HERITAGE VAUGHAN COMMITTEE

AGENDA

August 15, 2012

1. 667 NASHVILLE ROAD – HERITAGE REVIEW FOR DEMOLITION - WARD 1
2. 10 RICHMOND STREET – HERITAGE REVIEW FOR REVISION TO APPROVED ELEVATIONS – WARD 1
3. 26 OLD YONGE STREET – HERITAGE REVIEW OF PROPOSED SEASONAL AIR SUPPORTED TENNIS DOME STRUCTURE - WARD 5
4. 97 WOODBRIDGE AVENUE – HERITAGE REVIEW FOR DEMOLITION – WARD 2
5. 942 NASHVILLE ROAD – HERITAGE REVIEW FOR ADDITION TO GARAGE – WARD 1

Fig. 5. Proposed Revised Drawings, August 15, 2012.

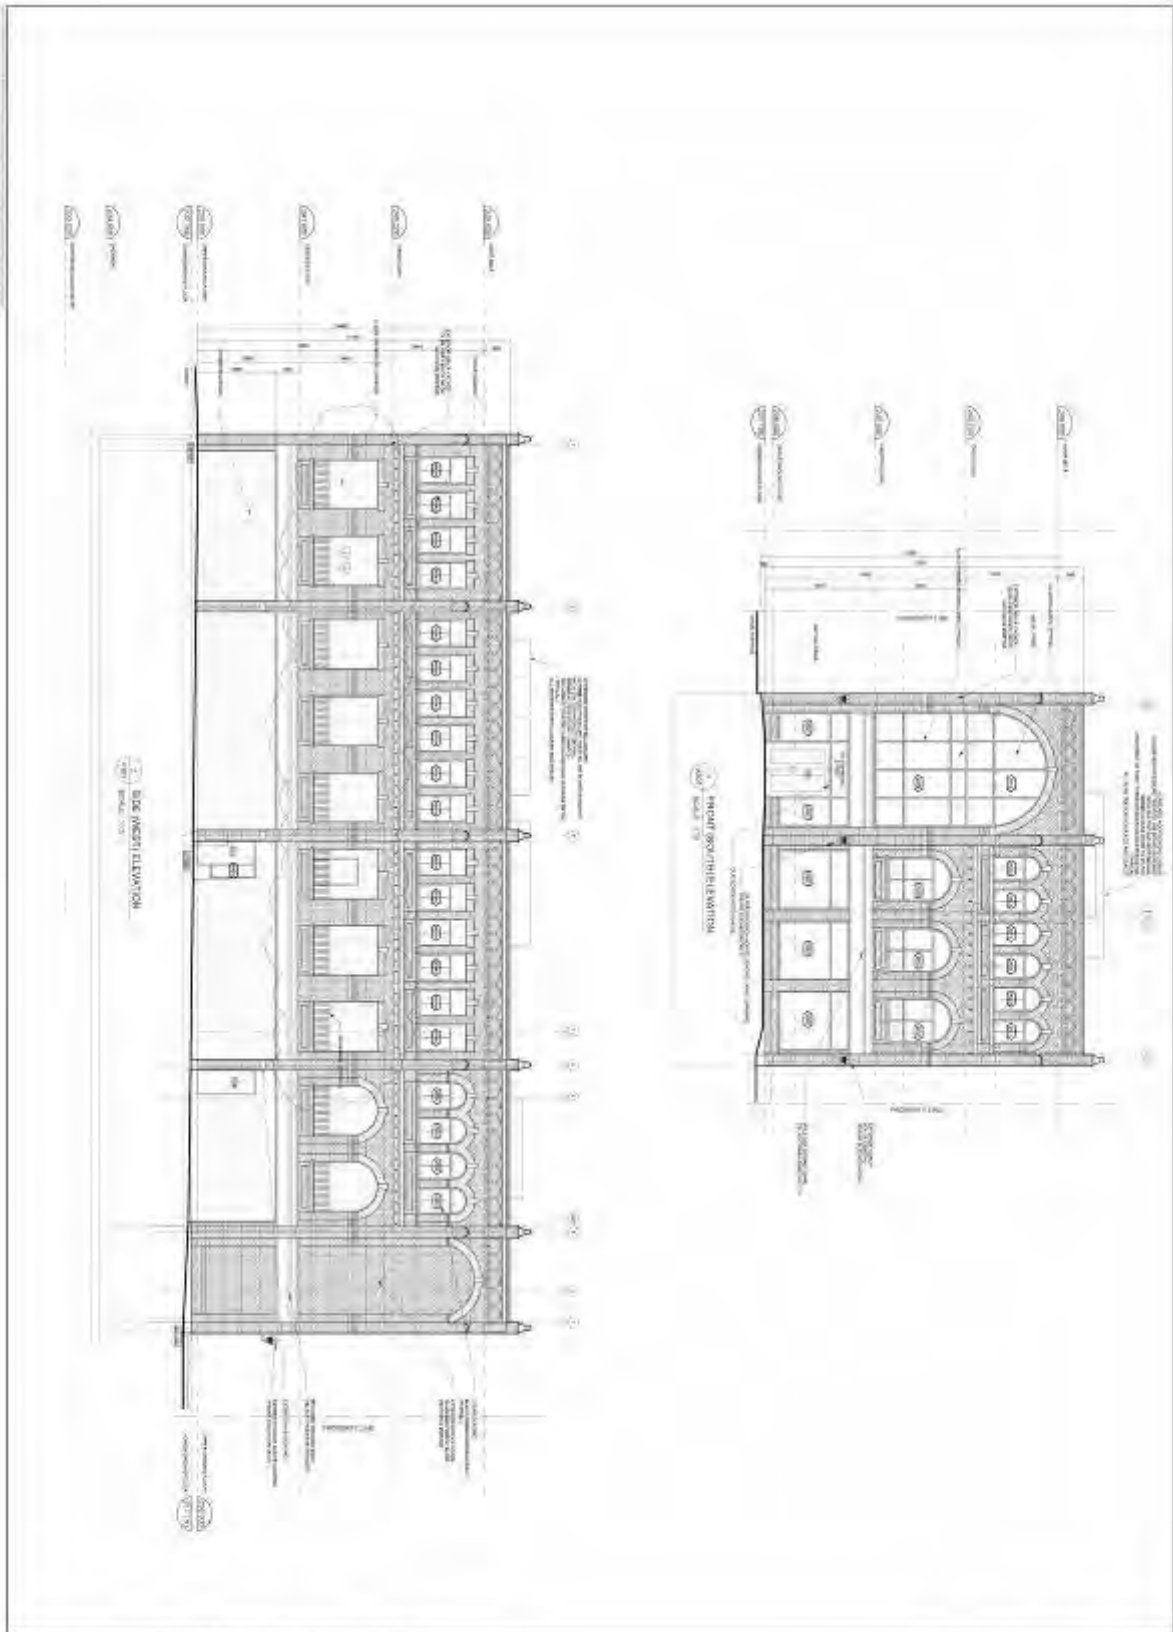
1. That Heritage Vaughan approved the proposed changes in window configuration and introduction of railings as reflected on the revised elevations noted in the analysis portion of this report, and;

2. That the applicant submit material samples for review and approval by Cultural Services staff when these are available, such as railings, metal panels and details, masonry accent details, etc; and,

3. The signage banding material must consist of a historically appropriate material including wood or metal in accordance to precedents of the style and appropriate externally illuminating lighting methods such as goose neck lighting (not interior illuminated wall sign).

- Front façade: large arched window: change brick divider into metal panels within frame. Change in keeping with precedent style, with contemporary materials.
- West (side) elevation: introduction of guard rails on second floor window openings. Change due to extension of second floor plate.
- North (rear) elevation: introduction of guard rails on second floor western bay window openings. Change due to extension of second floor plate.
- East (side)elevation: In the 2nd bay, elimination of glazing in three windows one on each floor. In the third bay, introduction of two windows. Fourth bay, introduction of 7 windows and elimination of one door. Fifth bay, elimination of 8 windows and introduction of one door. Changes due to changes in interior partitions.
